### **Workshop on ADS Safety Elements**

This document includes an editorial review of the ADS Safety Elements proposed in FRAV-12-08 based on comments received in the documents:

FRAV-18-06  
18<sup>th</sup> FRAV Session  
09 September 2021

Figure 2 — System-initiated transition from automated to manual driving (concepts are further specified in 5.3.2 and 5.3.3)

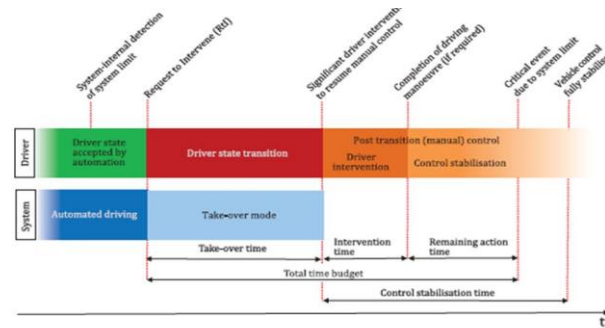
12	<p>The ADS should safely manage transitions of control to the user</p> <p><b>The ADS should assure a safe ADS feature activation</b></p>	<ol style="list-style-type: none"> <li>1) The ADS should inform the user that preconditions for activation are met</li> <li>2) The activation should follow a common sequence                         <ol style="list-style-type: none"> <li>a) Common sequence to be a pass/fail criterion</li> </ol> </li> <li>3) The ADS should provide confirmation that the system is activated</li> </ol>	
13	<p>The ADS should safely respond to user input errors</p> <p><b>The ADS should assure a safe Transition Of Control</b></p>	<ol style="list-style-type: none"> <li>1) The interaction should follow a common sequence in the transition of control (change of user roles)                         <ol style="list-style-type: none"> <li>a) Common sequence to be a pass/fail criterion</li> </ol> </li> <li>2) Transition of control should return to a common default user role (to prevent mode confusion <b>and other risks</b>)                         <ol style="list-style-type: none"> <li>a) This should normally be fully engaged driving (conventional driver)</li> <li>b) Common default user to be a pass/fail criterion</li> </ol> </li> <li>3) The ADS should <b>continuously</b> verify <b>whether</b> the user is available for the transition of control <b>and warn the user if not available when required</b> (MRM to be specified elsewhere)</li> <li>4) The ADS should verify that the driver is in stable control of the vehicle to complete the Transfer of Control to the user</li> </ol>

<p>5) <b>During transition, the ADS should remain active until the transfer of control has been completed or the ADS reaches a minimal risk condition</b></p>	
<p>14</p>	<p><del>The ADS should provide feedback to the user on its operational status</del></p> <p><b>The ADS should assure a safe user initiated take over</b></p>	<p>1) <b>Under safe conditions the user is allowed to initiate a take-over of the ADS</b></p> <p>2) The deactivation should follow a common sequence</p> <p>a) Common sequence to be a pass/fail criterion</p> <p>3) The ADS should <b>prevent and</b> warn a user for a user initiated take over that <b>would likely</b> lead to an unsafe situation</p> <p>4) The ADS should provide a clear feedback of the successful user initiated take over</p> <p>a) The clear feedback should be a pass/fail criterion</p> <p>5) The user initiated take over should return to a common default user role (to prevent mode confusion <b>and other risks</b>)</p> <p>a) This should normally be fully engaged driving (conventional driver)</p> <p>Common default user role to be a pass/fail criterion</p>
